### **AMENDMENTS TO THE DRAWINGS**

## REMARKS

1. In response to the final Office Action mailed February 26, 2004, Applicant respectfully requests reconsideration. Claims 1-29 and 44-65 were last presented for examination in this application. In the Office Action claims 1-29 and 44-65 were rejected. By the foregoing Amendments, claims 1, 8, 9, 25, 44, 49, 50, 52, 54, 57, 59-62 and 64 have been amended. No claims have been added or canceled. Thus, upon entry of this paper, claims 1-29 and 44-65 will remain pending in this application. Of these 51 claims, three (3) claims (claims 1, 25, and 44) are independent. Based on the above Amendments and following Remarks, Applicant respectfully requests that the outstanding objections and rejections be reconsidered, and that they be withdrawn.

FIGURE 3

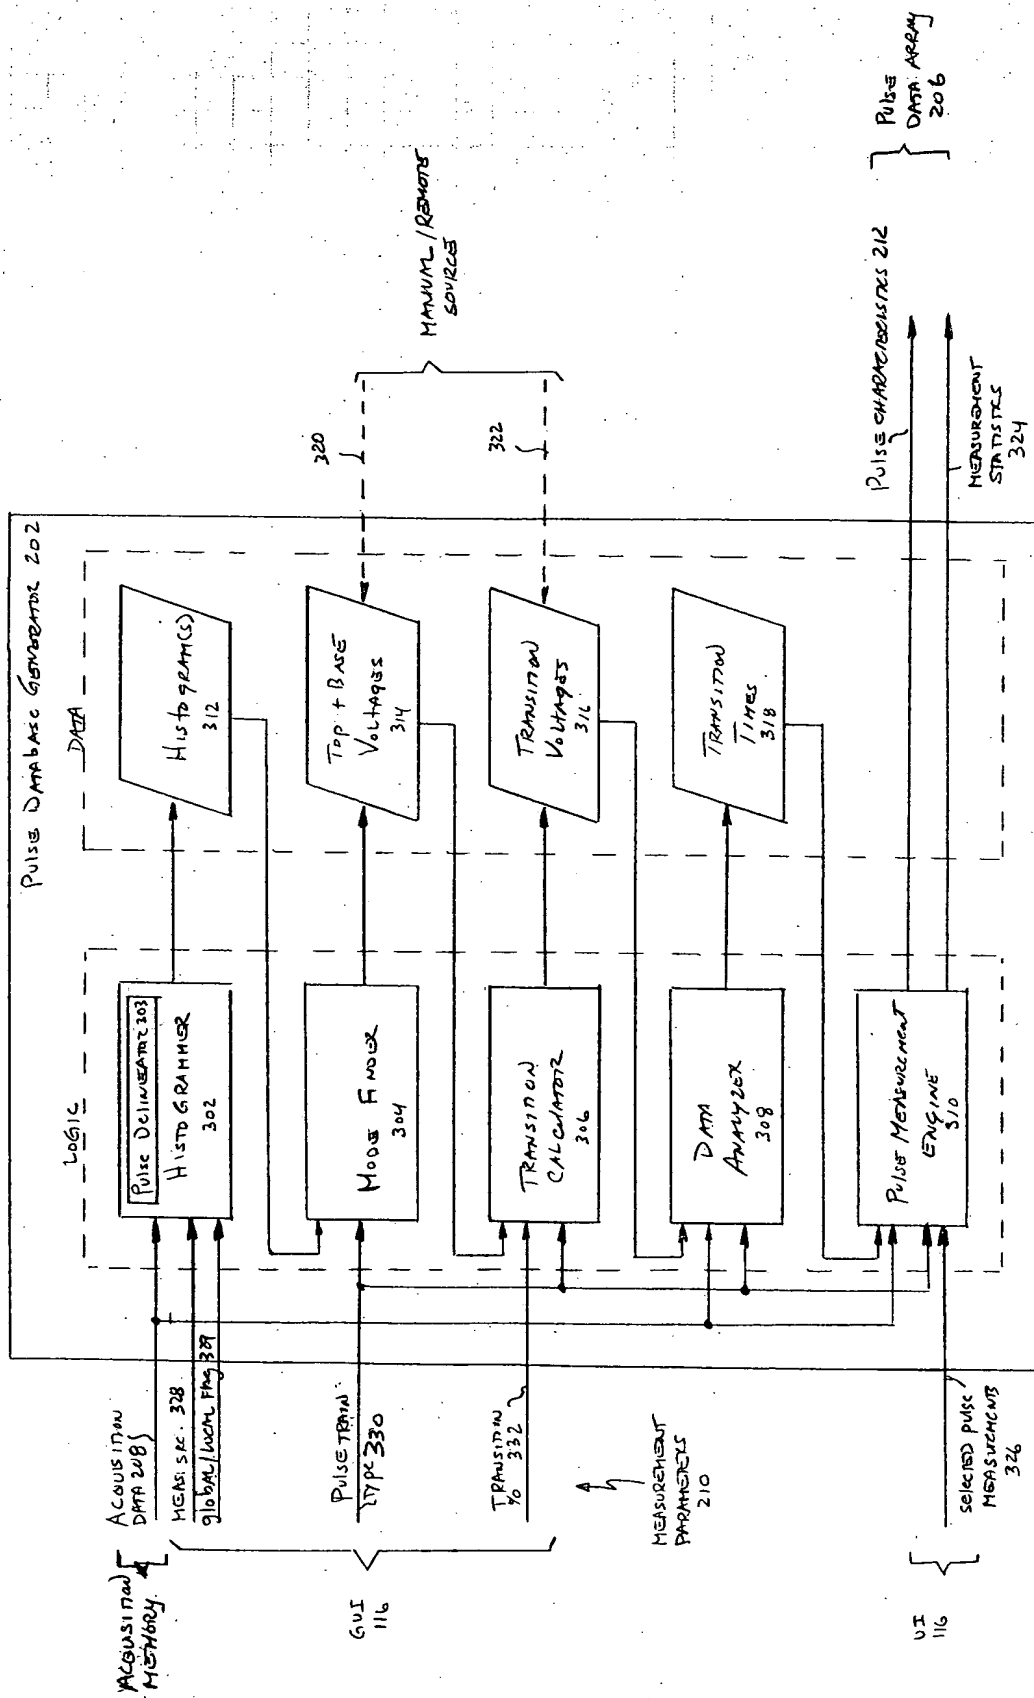
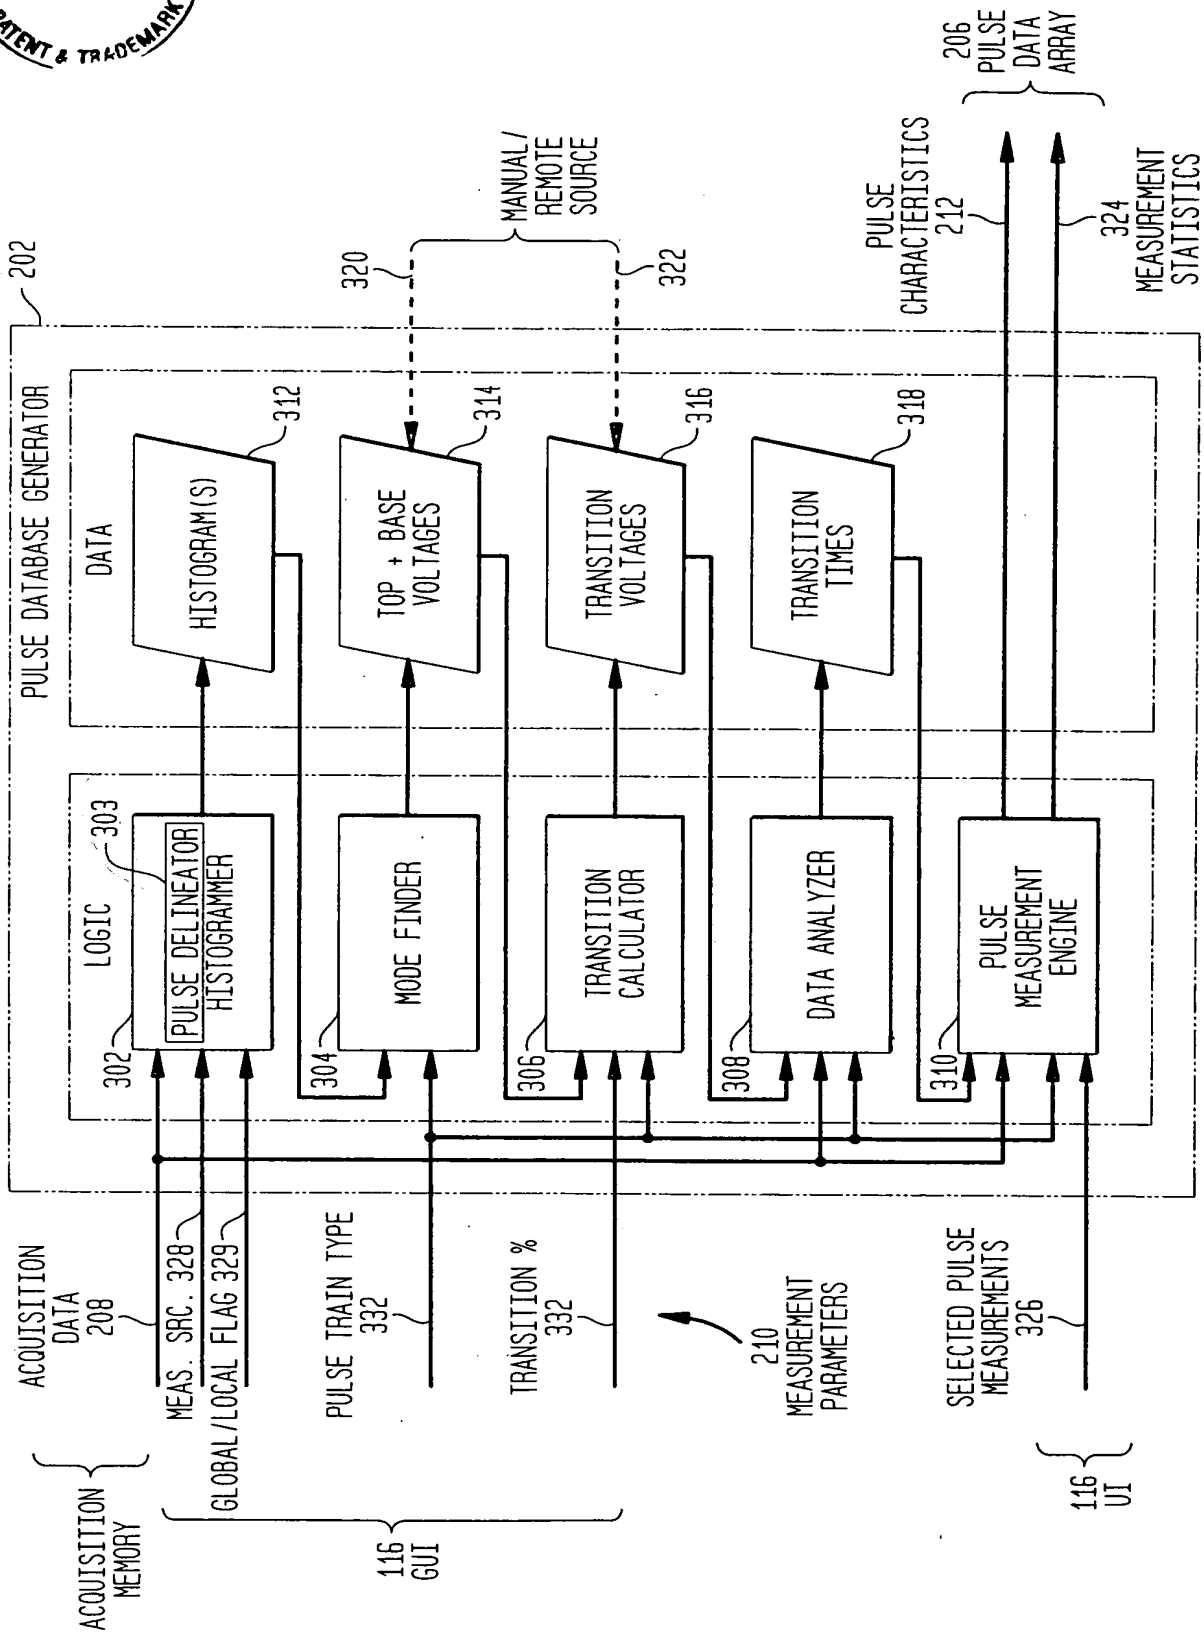
The attached one sheet of drawings includes changes to Figure 3. This sheet, which includes a proposed drawing change to Figure 3, replace the original sheet also including Figure 3. Reference "Pulse Train Type 332" has been changed to "Pulse Train Type 330"

3. The Examiner has objected to drawing Figures 3 and 9 under 37 CFR § 1.84(p)(5) for missing reference number "303", and reference numbers "900", "916", "922", and "928", respectively, which are mentioned in the specification. In the Response filed January 08, 2004, Applicant argued that the reference numbers were included in the figures, but the Examiner has maintained the objection in the current Office Action. The Examiner further explains in paragraph 14 of the current Office Action that the Examiner sees in the figures the mentioned items, but that the labels are missing. To resolve this issue, Applicant submits as Appendix A a copy of the informal drawings filed with the original Application, with the disputed numbers highlighted. Because Applicant is unsure if the Examiner is referring to the informal drawings or the formal drawings, Applicant also submits in Appendix A a copy of the formal drawings, with the disputed reference numbers highlighted.

4. Applicant identified an error in Figure 3. An informal drawing with red-lines correcting the error is submitted with this Amendment as Appendix B. In Figure 3, the reference Pulse Train Type 332 has been changed to Pulse Train Type 330. After receiving approval by the Examiner for the change, Applicant will submit corrected formal drawings.
